### Town of Thompson's Station Municipal Planning Commission Meeting Agenda June 28, 2016

### Thompson's Station Planning Commission Staff Report – Item 1 (PP 2016-004) June 28, 2016

### Thompson's Station Planning Commission Staff Report – Item 2 (File: SP 2016-003) June 28, 2016

### Thompson's Station Planning Commission Staff Report - Item 3 (File: FP 2016-002) June 28, 2016

PRELIMINARY PLAT

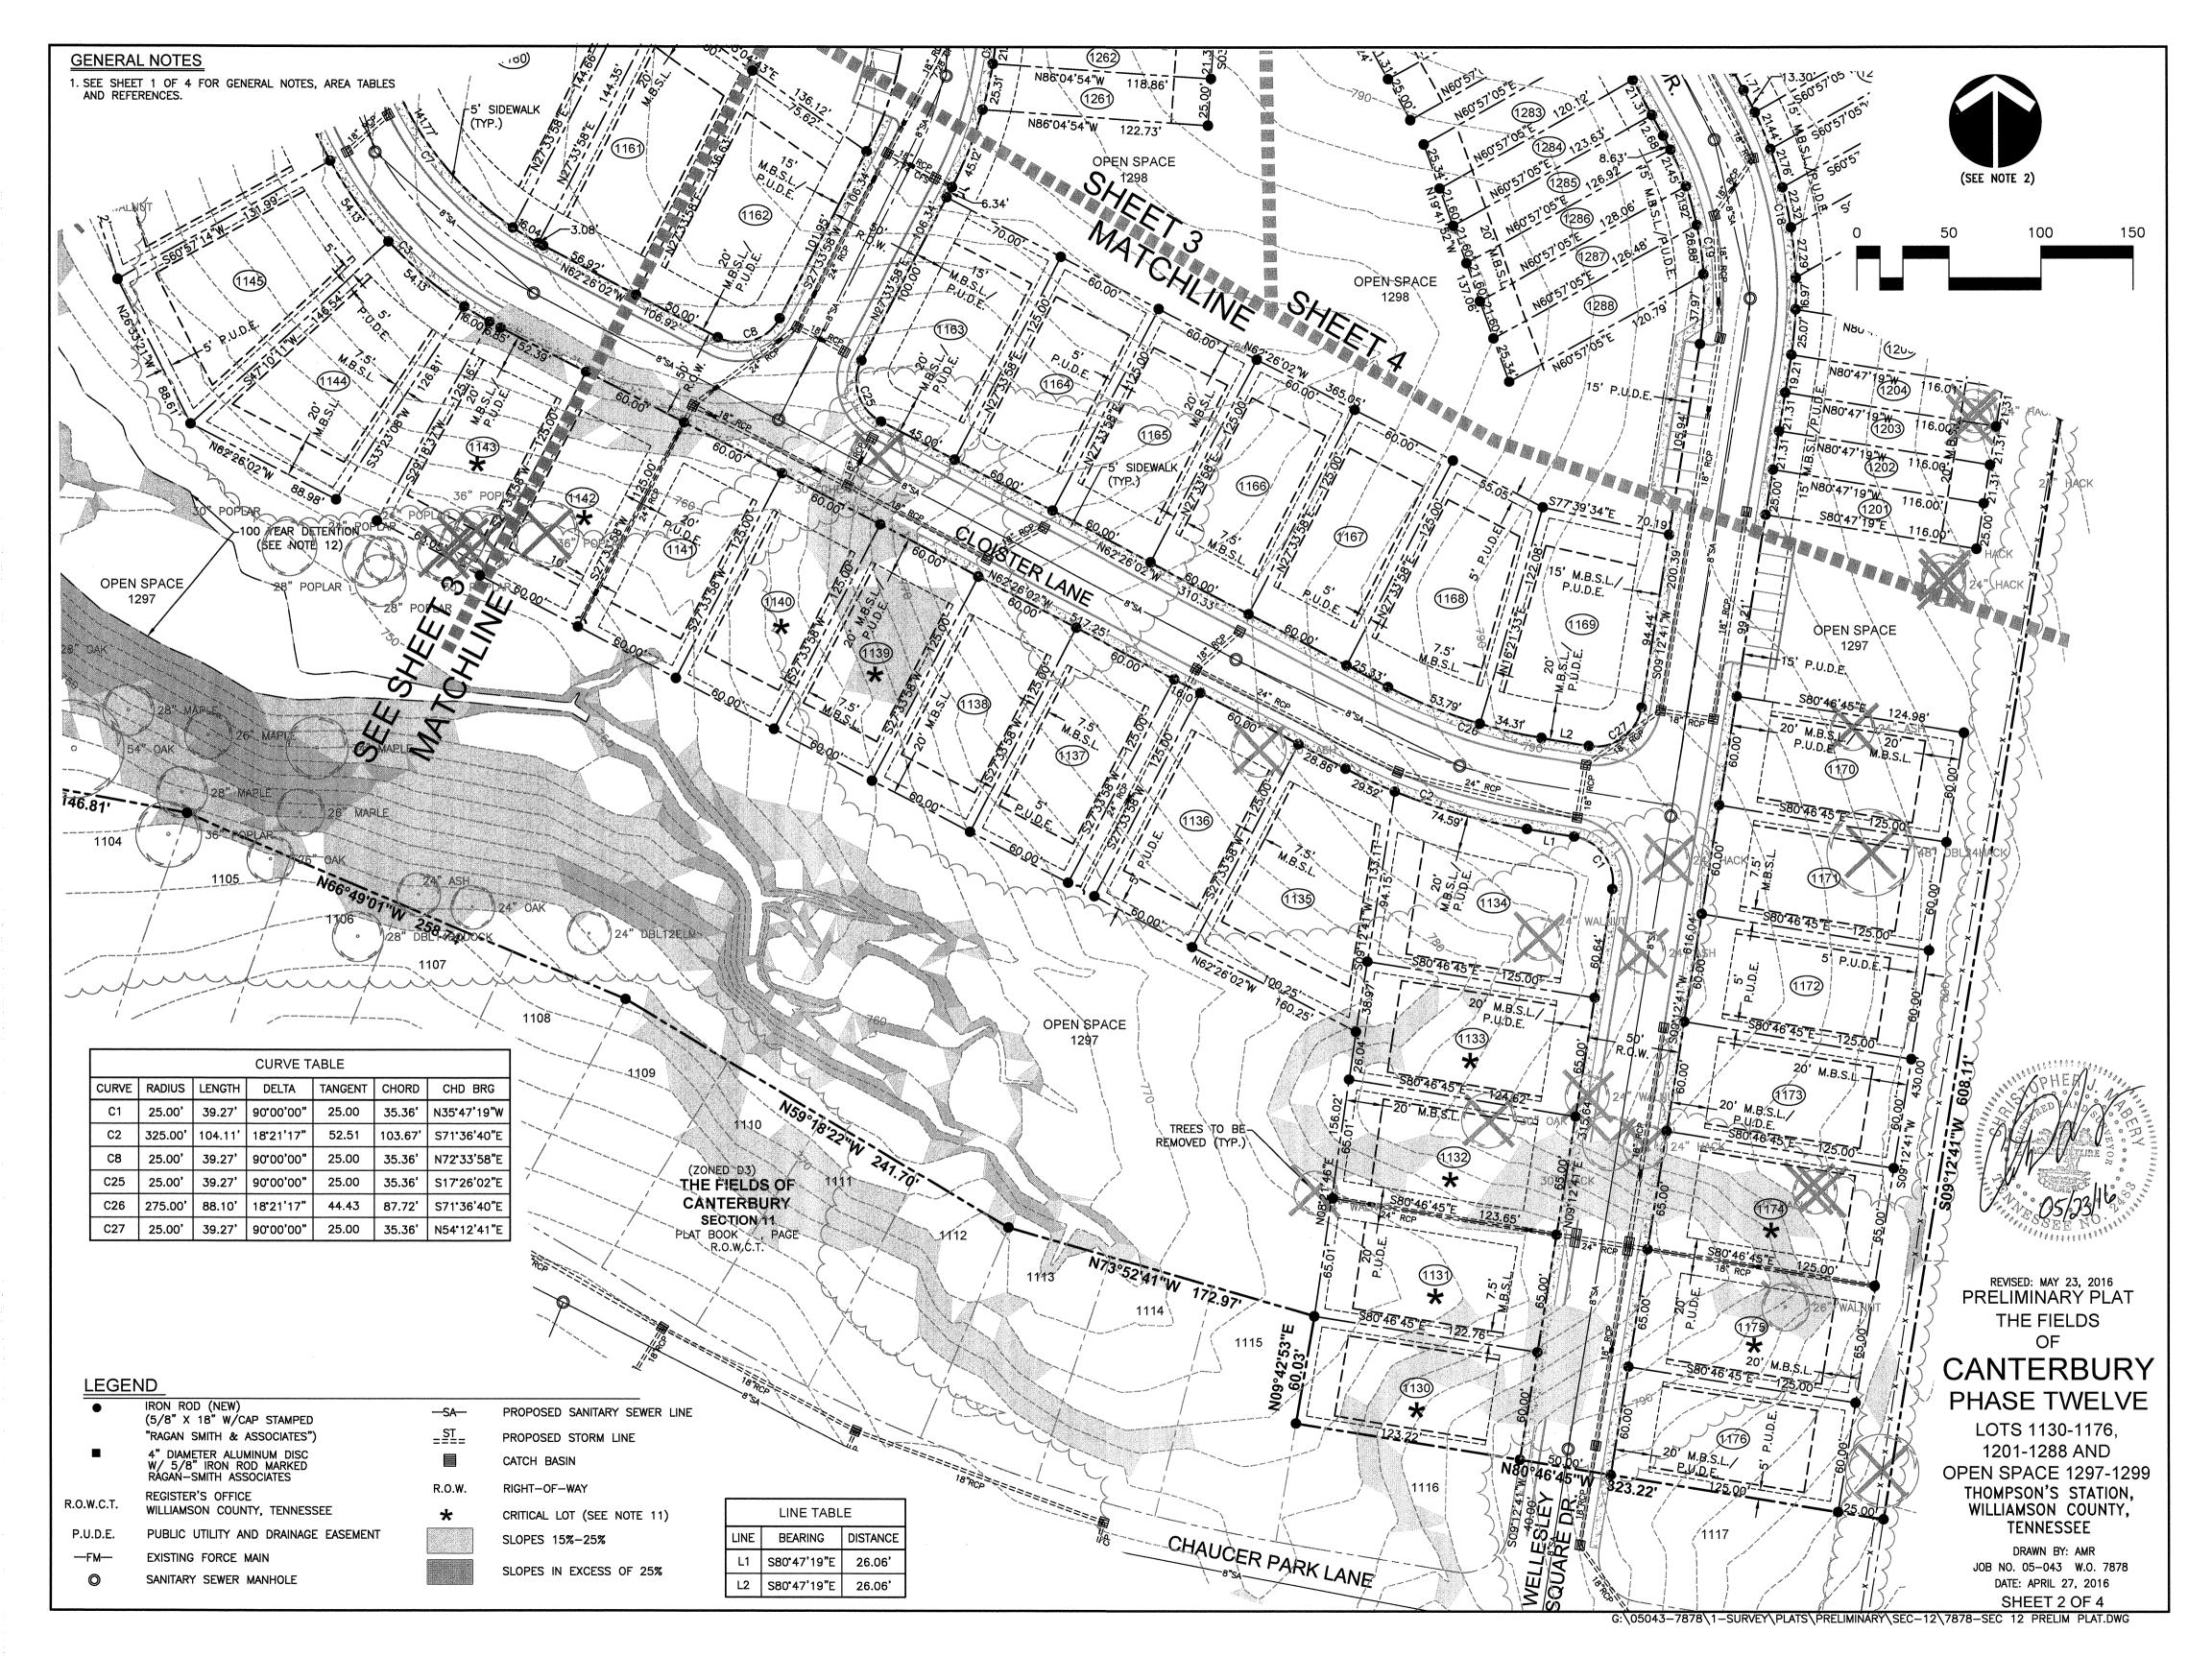
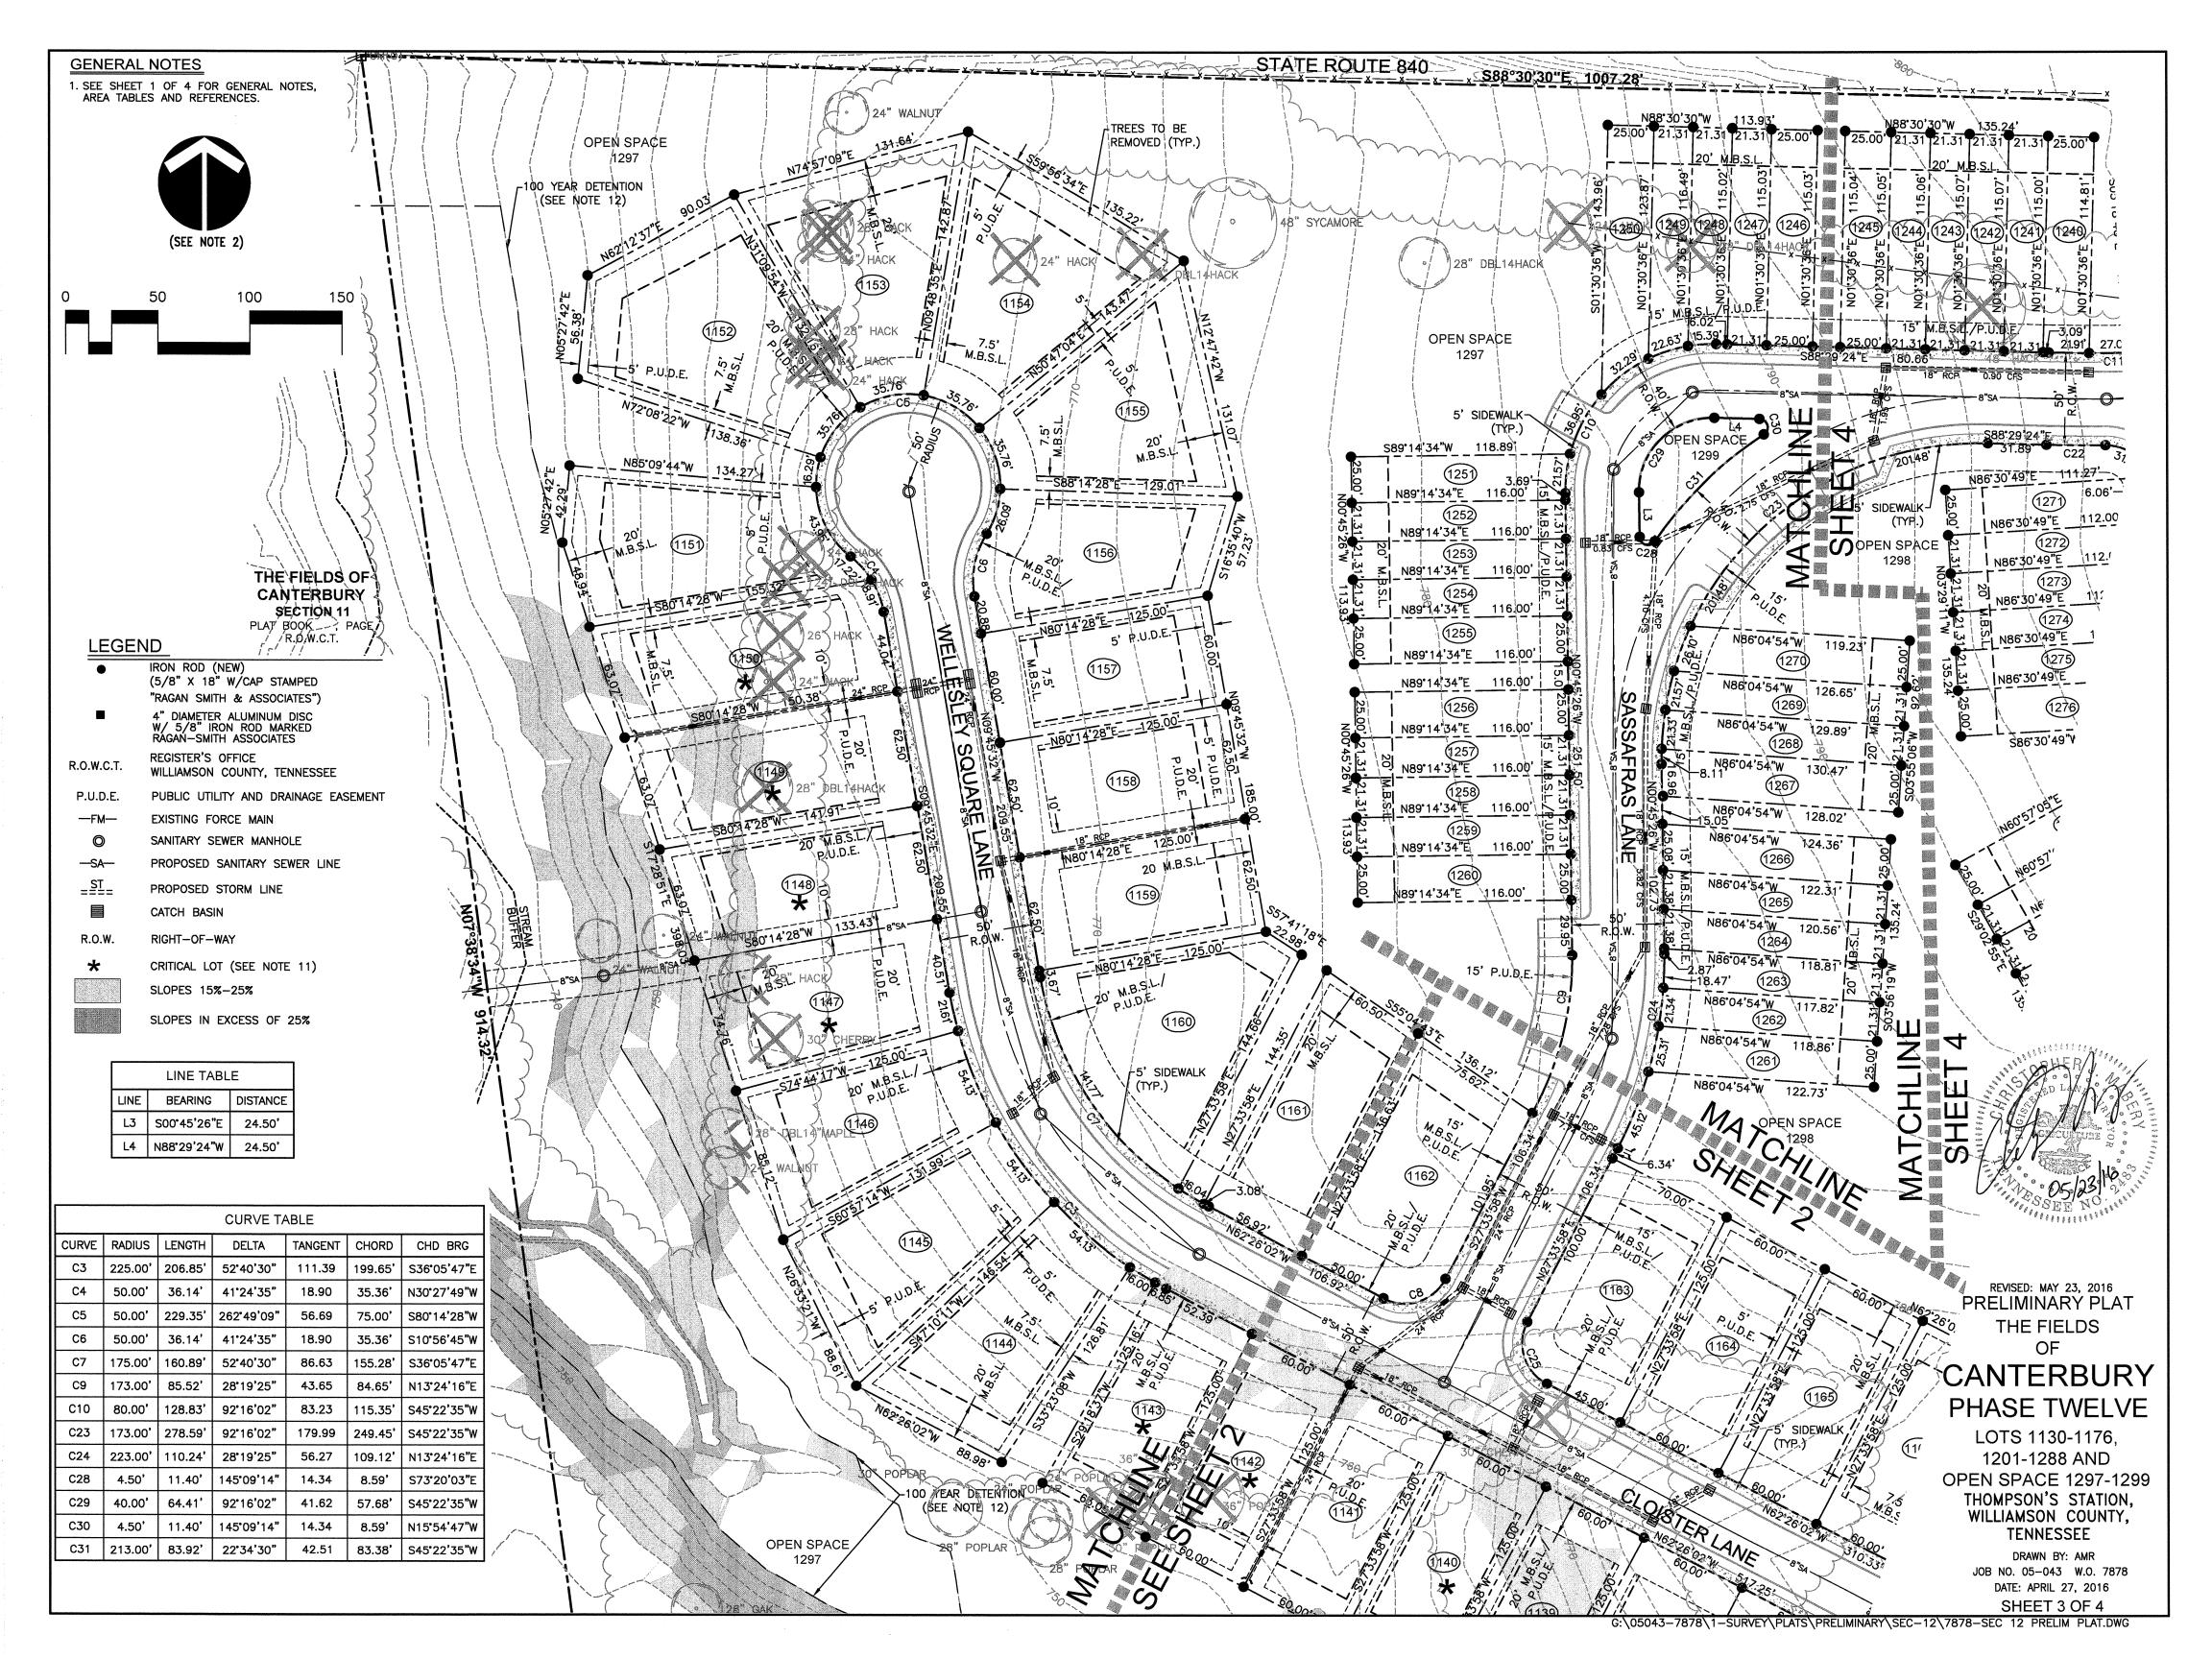
No development will occur on slopes exceeding 25%; however, several lots contain slopes between 15 and 25% and are critical lots due to these slopes. Lots 1130-1133, 1139-1140, 1142-1143, 1147-1150 and 1174 – 1175 are designated as critical lots on the plat. A mass grading plan will be reviewed with the construction plans and all critical lots will require engineered site plans to address all site specific issues when building permit is required.

Development of phase 12 will result in the removal of 45 trees for a total of 1,248 inches. The Land Development Ordinance requires the replacement of trees 24 inches and greater at a ratio of one and a half inches for every inch removed. Therefore, 1,872 inches of trees is required to be replaced on the site. The replacement plan includes one tree per each single-family lot for a total of 47 trees, one tree for each townhome lot for a total of 88 trees, 82 street trees and 326 "phase" trees. These 543 trees total 1,080 inches of the necessary replacement trees. The replacement plan also includes the existing trees located at the main entrance along Critz Lane, the berm and open space plantings in phase 10, and the amenity center trees for a total of 792 inches. The trees included in the replacement plan were trees planted by the developer and therefore, can be included to satisfy the requirements. Therefore, the replacement plan is consistent with the Land Development Ordinance.

While the preliminary plat provides an entitlement to move forward with the phase, construction plans are submitted, but review is not complete at this time. The construction documents provide all the necessary engineering for the development. During the review of the construction drawings, any engineering issues that are identified, including but not limited to grading, drainage, etc. will be required to be addressed adequately prior to approval. Therefore, any issues that arise during the construction plan review will be incumbent on the applicant to revise the preliminary plat accordingly to meet all engineering related standards.

Based on the project's consistency with the site development plan and the Town's Land Development Ordinance, Staff recommends that the Planning Commission approve the preliminary plat with the following contingencies:

- 1. Prior to the approval of construction plans, the applicant shall enter into a development agreement for the project.
- 2. Prior to the approval of construction plans, all applicable codes and regulations shall be addressed to the satisfaction of the Town Engineer.
- 3. Prior to the approval of construction plans, a drainage study shall be submitted to verify that drainage is managed adequately on site.
- 4. Prior to the approval of construction plans, a mass grading plan shall be submitted for review and approval.
- 5. During construction, the developer shall comply with Section 8.0 Recommendations, including 8.1 Earthwork, 8.2 Structural Fill, 8.3 Groundwater control and 8.4 Sinkhole Considerations from the geotechnical report dated June 1, 2016.
